INC DCN IS102-031B-5 PER DCR 00-1766	SBW	10/1/00	14
INC DCN IS102-031B-1 PER MOD P3-0039 SUP-0			
INC DCN'S IS102-031B-2,3 & 4 FOR DCR 91-001			
ISSUED FOR SECOND 10 YEAR ISI PROGRAM			
NO. DATE	REVISIONS	BY	CHK'D
1			
2			
3			
DAVIS-BESSE NUCLEAR POWER STATION UNIT NO. 1			
INSERVICE INSPECTION DIAGRAM			
MAKE-UP & PURIFICATION SYSTEM			
DRAWING NO.		REV.	
IS102-031B		3

D-20

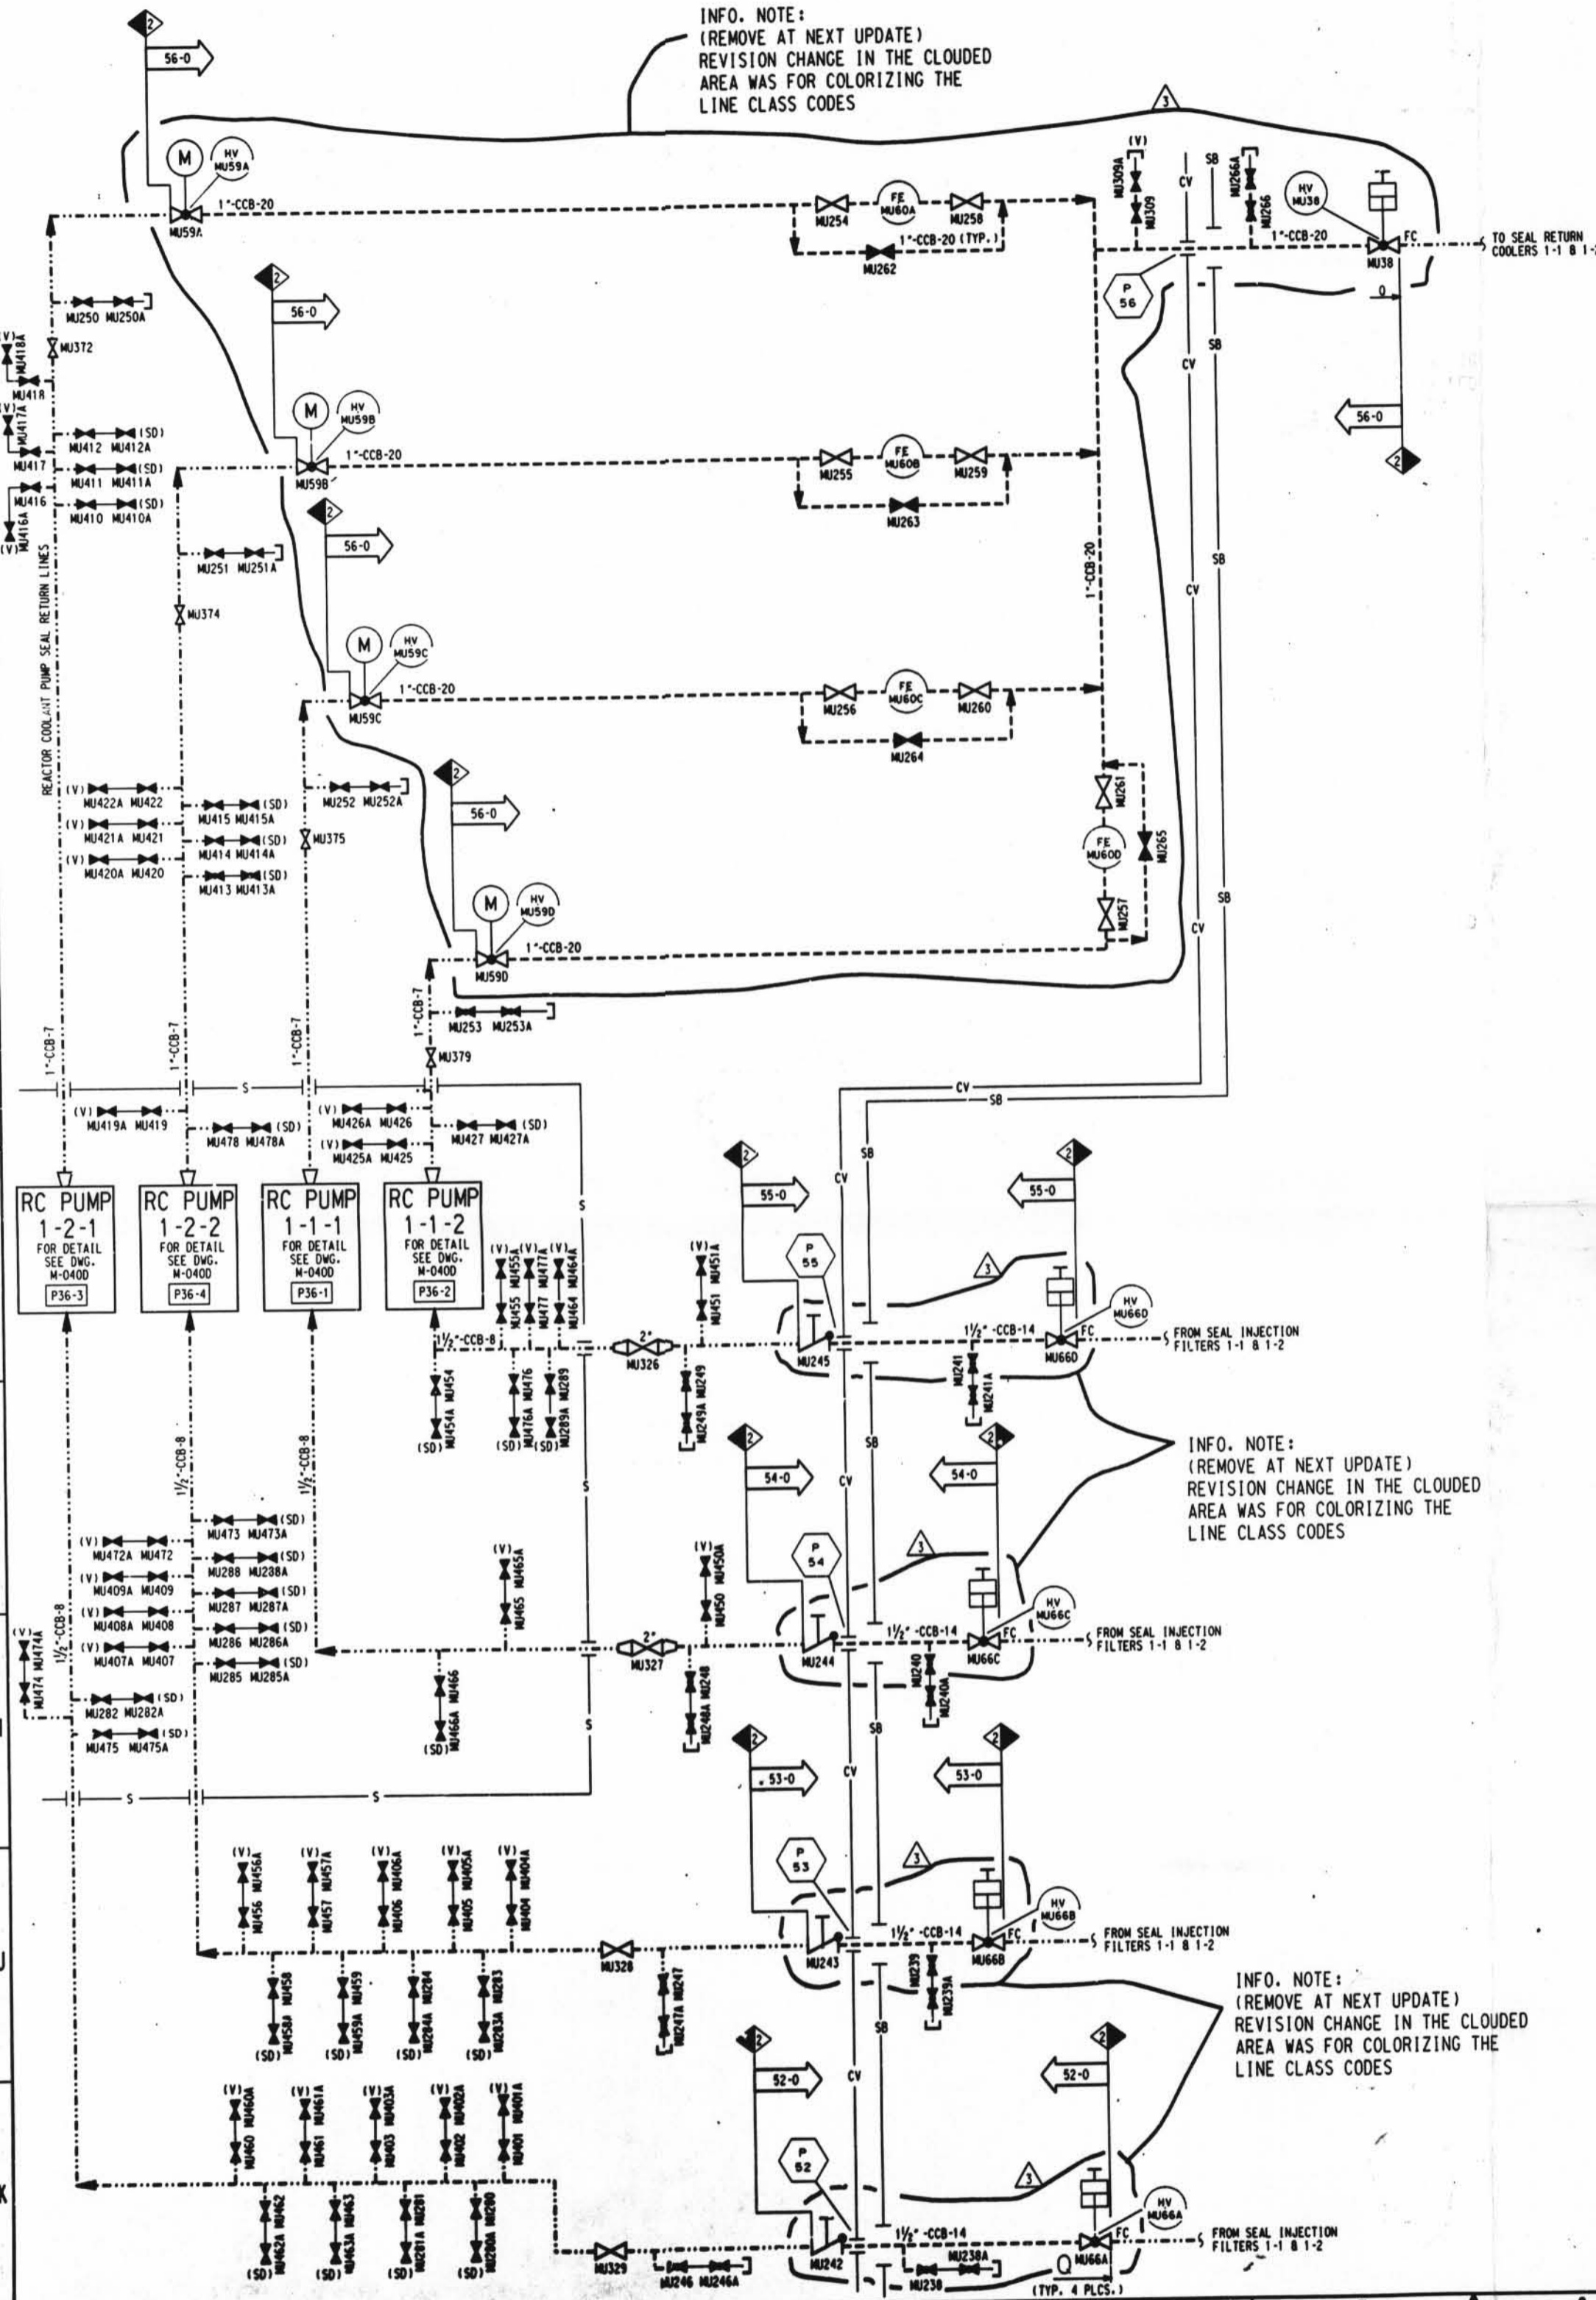
INFO. NOTE:  
(REMOVE AT NEXT UPDATE)  
REVISION CHANGE IN THE CLOUDED  
AREA WAS FOR COLORIZING THE  
LINE CLASS CODES

INFO. NOTE:  
(REMOVE AT NEXT UPDATE)  
REVISION CHANGE IN THE CLOUDED  
AREA WAS FOR COLORIZING THE  
LINE CLASS CODES

INFO. NOTE:  
(REMOVE AT NEXT UPDATE)  
REVISION CHANGE IN THE CLOUDED  
AREA WAS FOR COLORIZING THE  
LINE CLASS CODES
